SEWAGE DISPOSAL SYSTEM

MARYLAND STATE DEPARTMENT OF HEALTH

PROPERTY OWNER Virginia Ridgely

P 45837
 A REPAIR

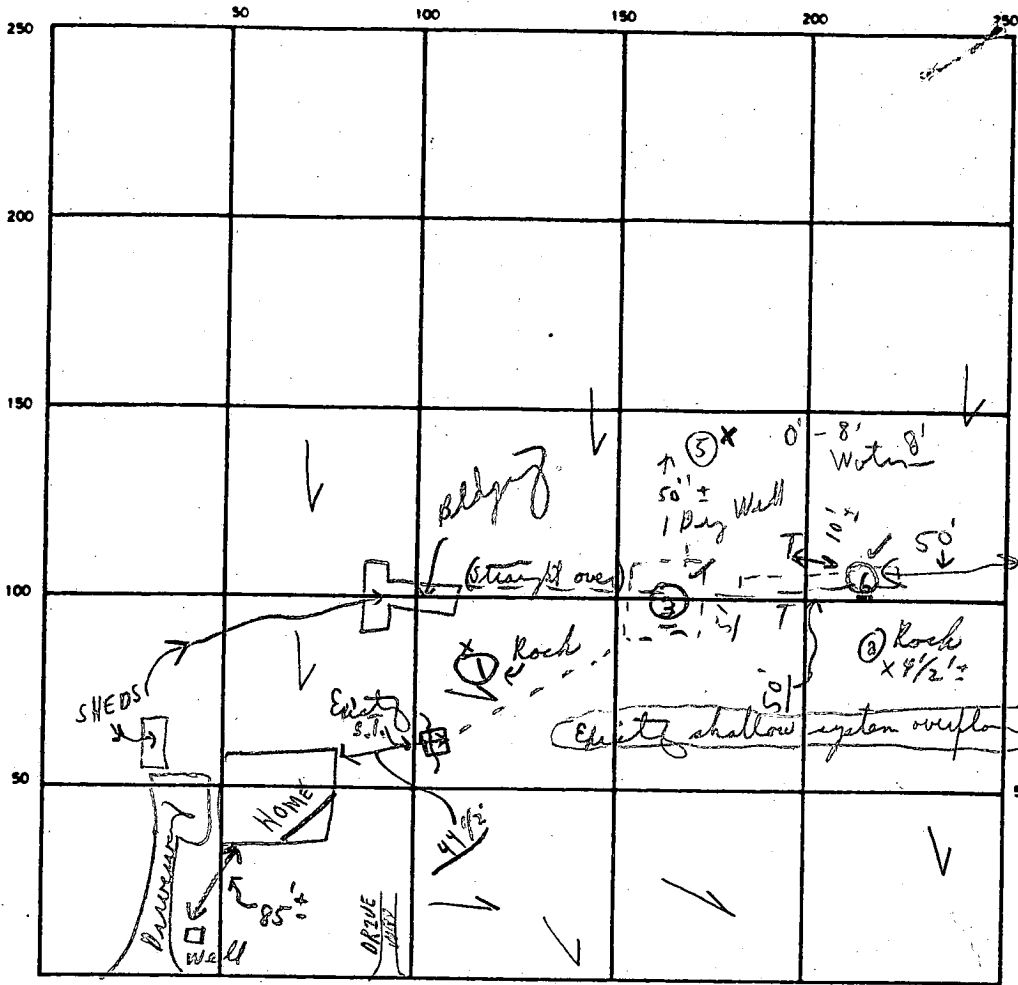
4/30/90 {
 ① Hole #3 Dry Well 15'x15' - 12'± lid inlet Man Depth 4' 9'
 5'x60' 300 sq. ft.
 ② Trench 50' long, 2' wide 5' of stone inlet 4' Man Depth 4' 9/2'
 off Dry Well 250 sq. ft.
 Total 550+ sq. ft.
 gravity flow inlet 5 1/2' ±
 1 dry well + 2 trenches 6' ±
 Late P.M.

600. ← Need New c.o. in time

SEPTIC TANK LEVEL Use existing

CLEANOUTS (To be put on)

DISTRIBUTION BOX LEVEL (Use New Dry Well)

REMARKS 4/30/90 Partial - 2 of the 6 holes are ok - 1 (15x15 Dry Well; 4'x3' to 4' - Maximum 9' depth and 1 trench 50' 5'± deep)
Limited repair area or redesign 2 Trenches off dry well
& gravity flow; 5/7/90 P.M. Partial - ok for stone in #1 trench and to continue work on system only.
5/7/90 Late p.m. - Drywell almost complete and #1 c.B.D. Trench
 DATE SYSTEM APPROVED 5/7/90 INSPECTOR Charles Bryan Utter
→ CIBD. → Hold for drawings from contractor or see above. Pg. 1
